Form 3160-5  
(June 2019)

8. Well Name and No. MODELO 10 FED COM/584H

EOG respectfully requests an amendment to our approved APD for this well to reflect the following changes:

Modelo 10 Fed Com 213H (FKA 584H) API #: 30-025-50944

# Design A

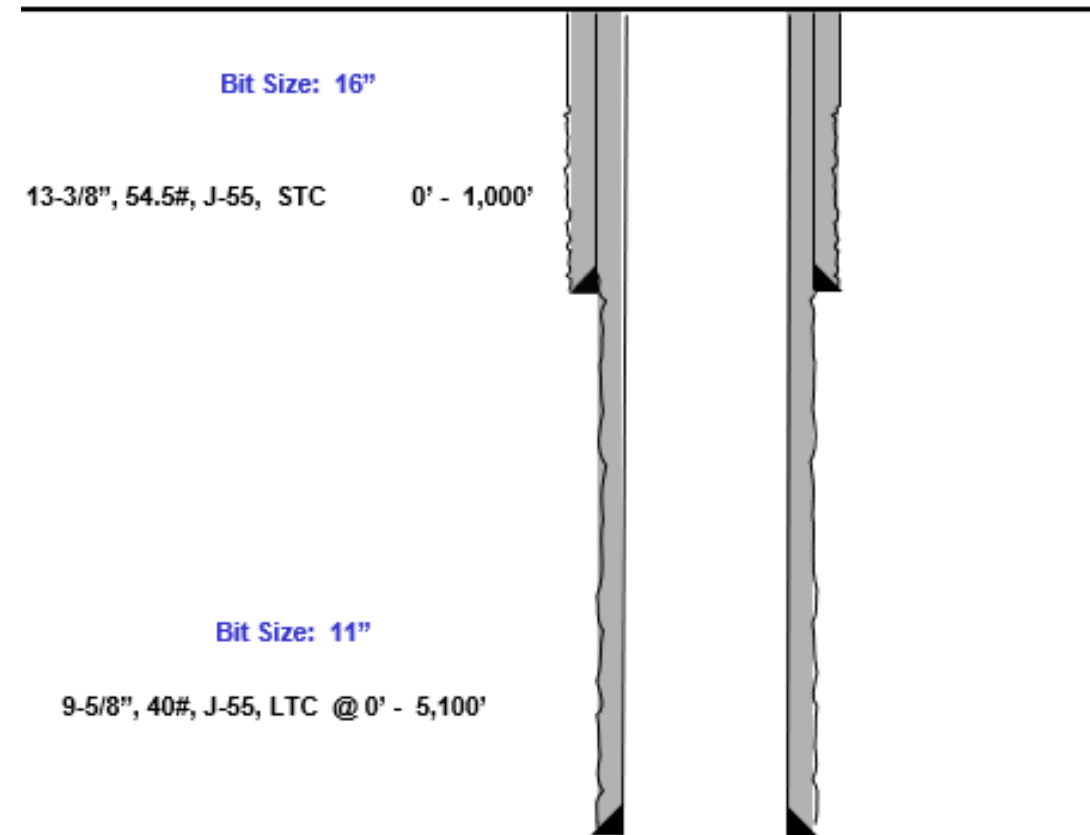
## Proposed 11" Hole with 9.625" 40# J55/HCK55 LTC Casing

- 11" Bit + 0.52" Average hole enlargement = 11.52" Hole Size
  - 0.9475" Clearance to casing OD

$$= \frac{11.52 - 9.625}{2}$$
  - 0.4475" Clearance to coupling OD

$$= \frac{11.52 - 10.625}{2}$$
- Previous Shoe – 13.375" 54.5# J55 STC
  - 0.995" Clearance to coupling OD (~1,200' overlap)

$$= \frac{12.615 - 10.625}{2}$$

# Design B

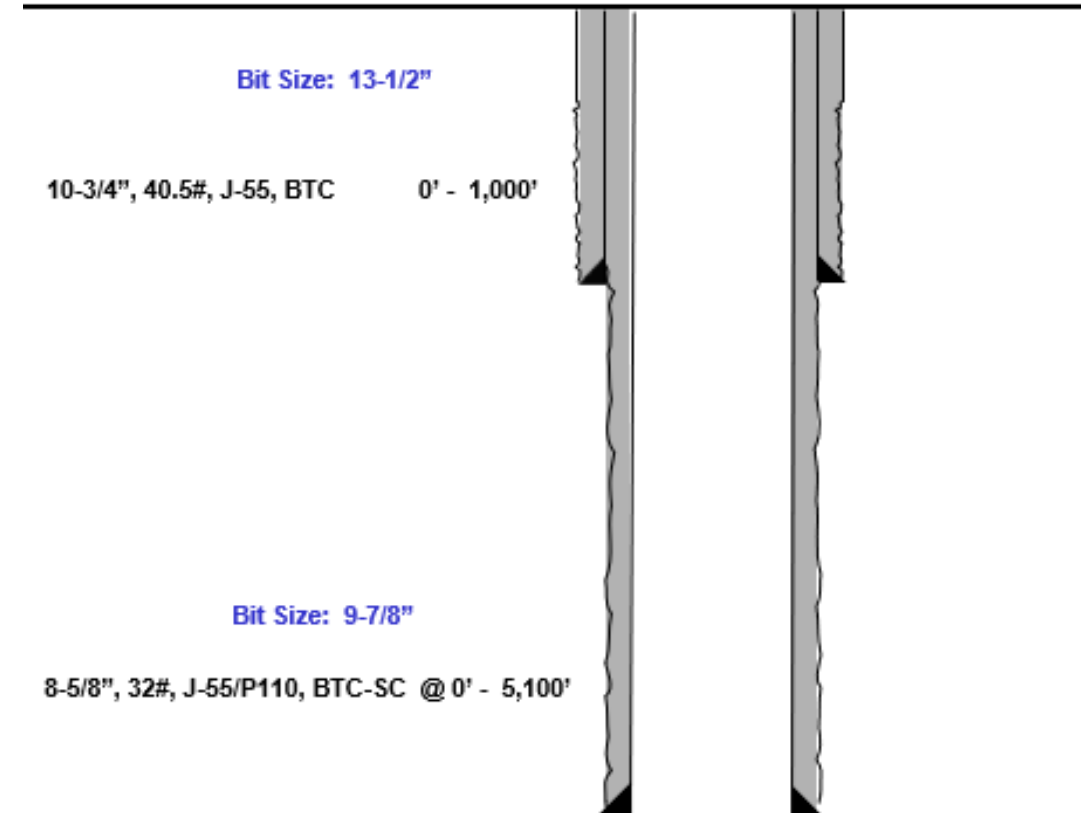
## Proposed 9.875" Hole with 8.625" 32# J55/P110 BTC-SC Casing

- 9.875" Bit + 0.42" Average hole enlargement = 10.295" Hole Size
  - 0.835" Clearance to casing OD

$$= \frac{10.295 - 8.625}{2}$$
  - 0.585" Clearance to coupling OD

$$= \frac{10.295 - 9.125}{2}$$
- Previous Shoe – 10.75" 40.5# J55 STC
  - 0.4625" Clearance to coupling OD (~1,200' overlap)

$$= \frac{10.05 - 9.125}{2}$$

# Break Test Diagram (HCR valve)

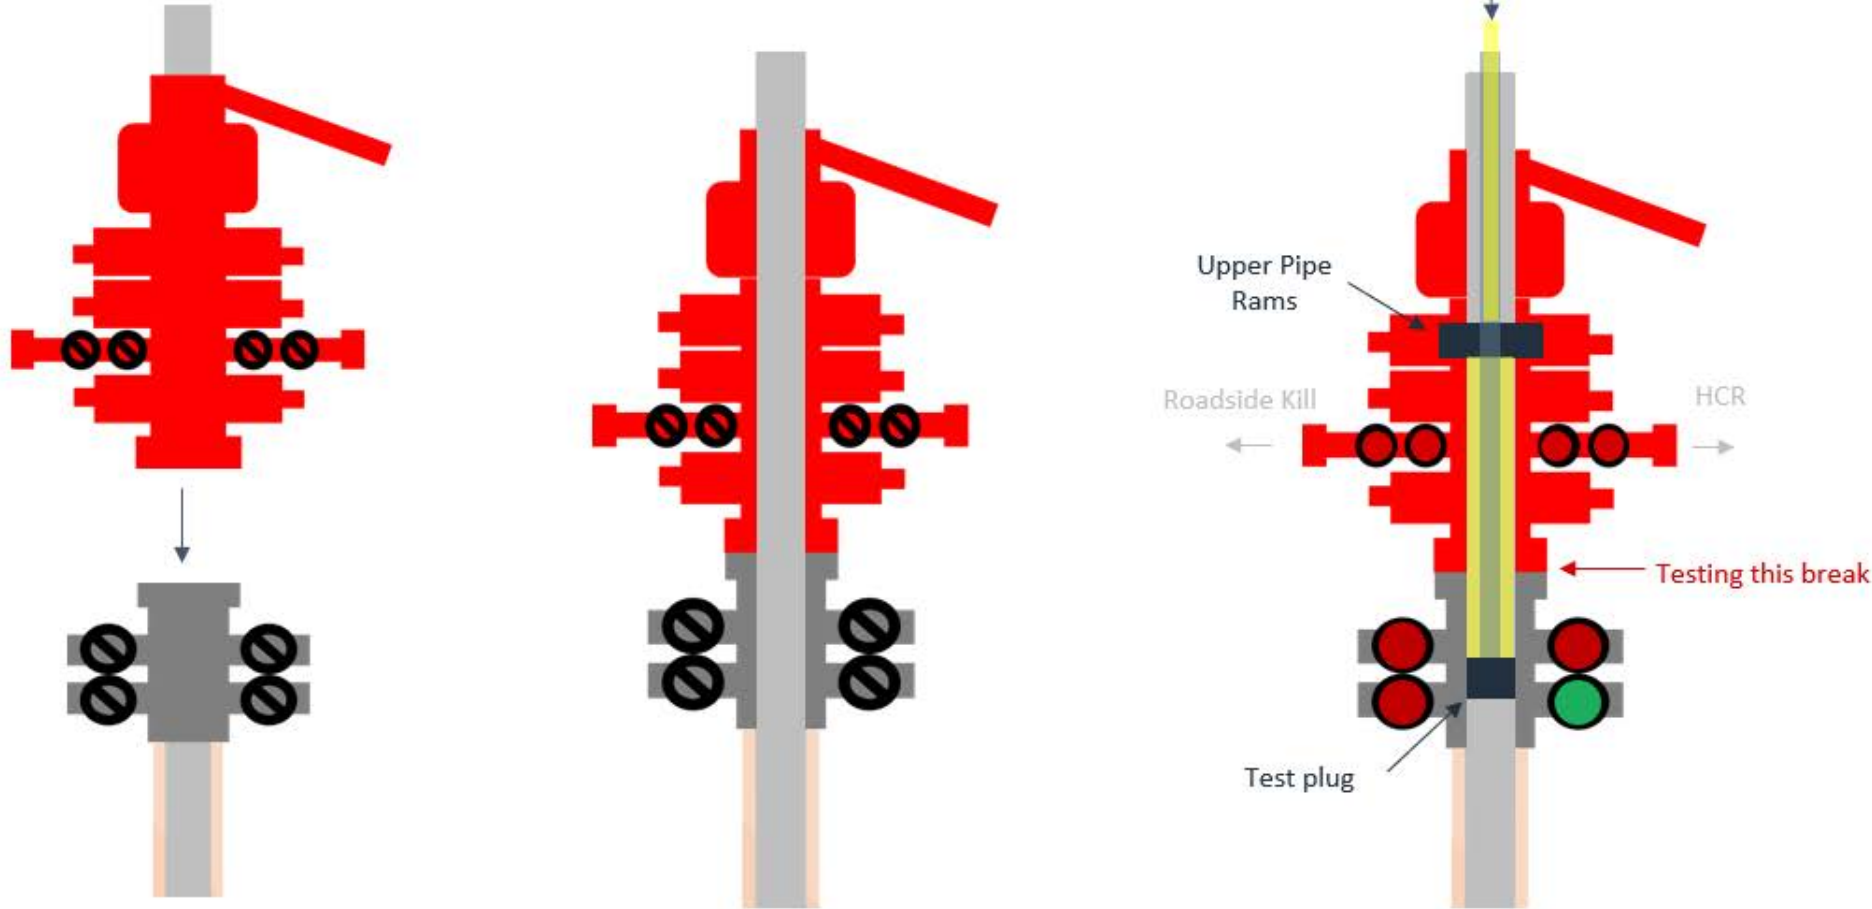
1. Set plug in wellhead (lower barrier)
2. Close Blind Rams (upper barrier)
3. Close roadside kill
4. Open HCR (pressure application)
5. Open wellhead valves below test plug to ensure if leak past test plug, pressure won't be applied to wellbore
6. Tie BOP testers high pressure line to main choke manifold crown valve
7. Pressure up to test break
8. Bleed test pressure from BOP testing unit

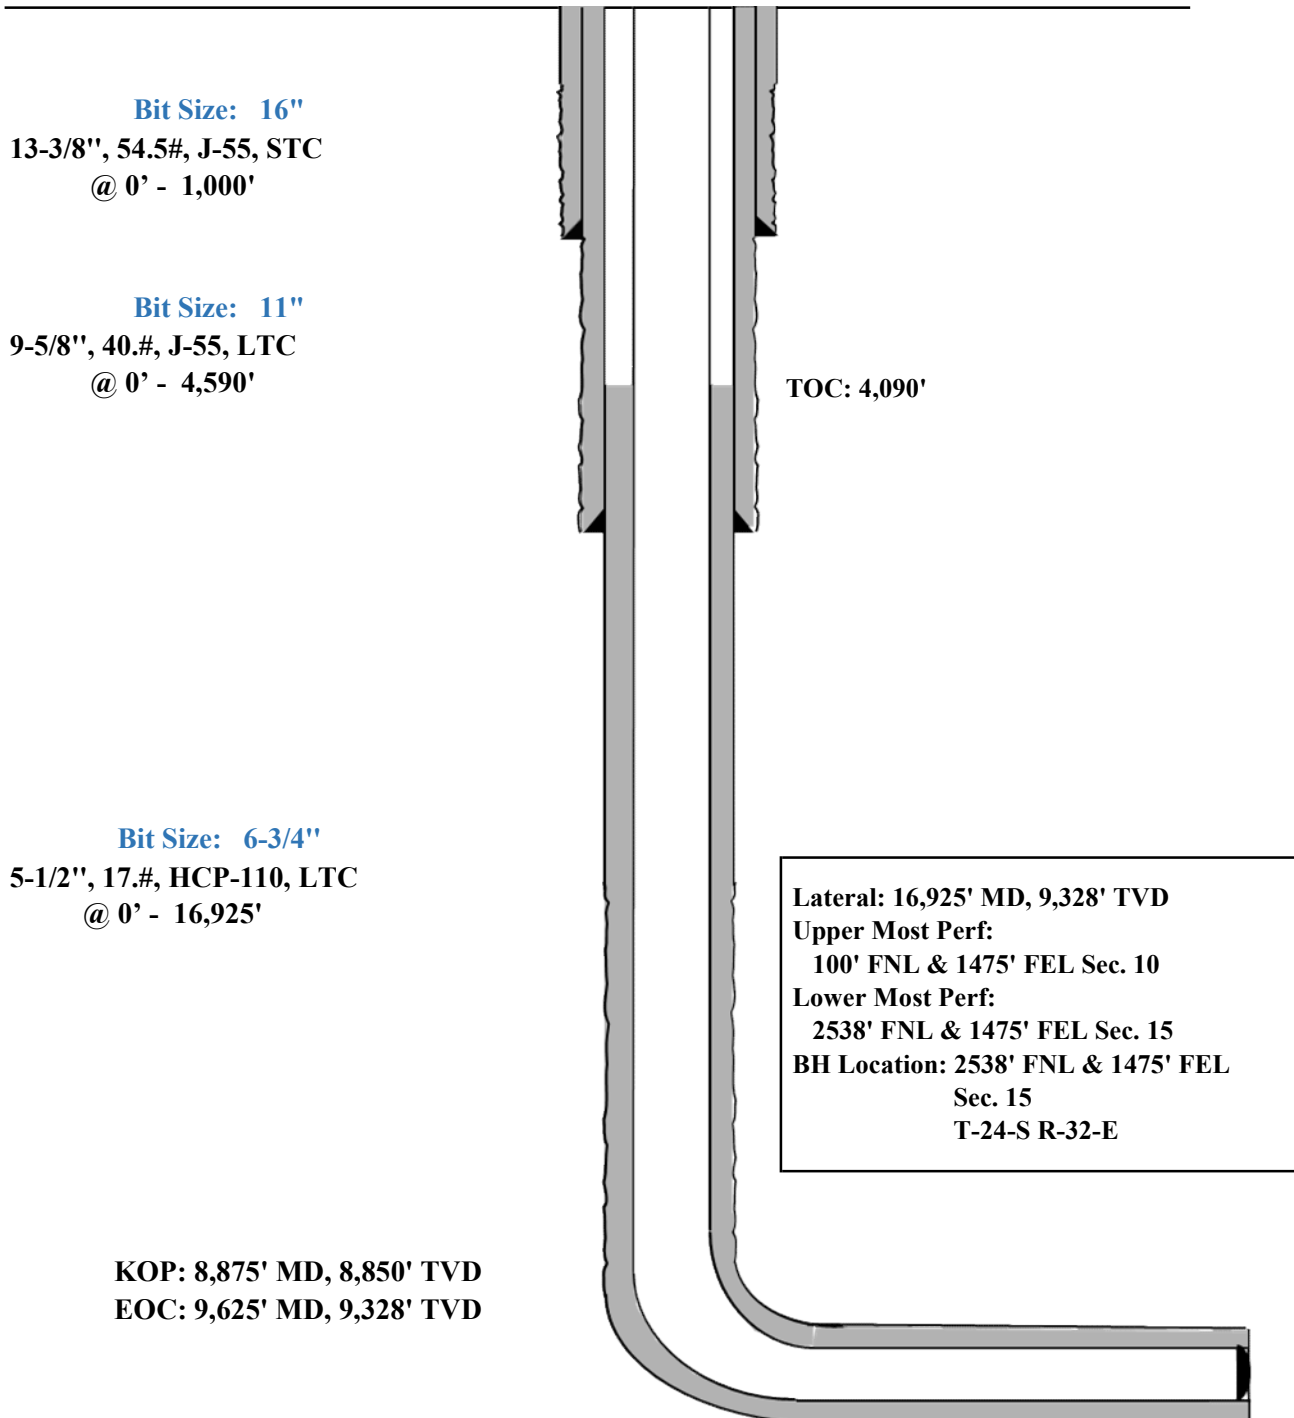
EOG respectfully requests an exception to the following NMOCD rule:

- 19.15.16.10 Casing AND TUBING REQUIREMENTS:  
J (3): “The operator shall set tubing as near the bottom as practical and tubing perforations shall not be more than 250 feet above top of pay zone.”

With horizontal flowing and gas lifted wells an end of tubing depth placed at or slightly above KOP is a conservative way to ensure the tubing stays clean from debris, plugging, and allows for fewer well interventions post offset completion. The deeper the tubulars are run into the curve, the higher the probability is that the tubing will become stuck in sand and or well debris as the well produces over time. An additional consideration for EOT placement during artificial lift installations is avoiding the high dog leg severity and inclinations found in the curve section of the wellbore to help improve reliability and performance. Dog leg severity and inclinations tend not to hamper gas lifted or flowing wells, but they do effect other forms of artificial lift like rod pump or ESP (electric submersible pump). Keeping the EOT above KOP is an industry best practice for those respective forms of artificial lift.
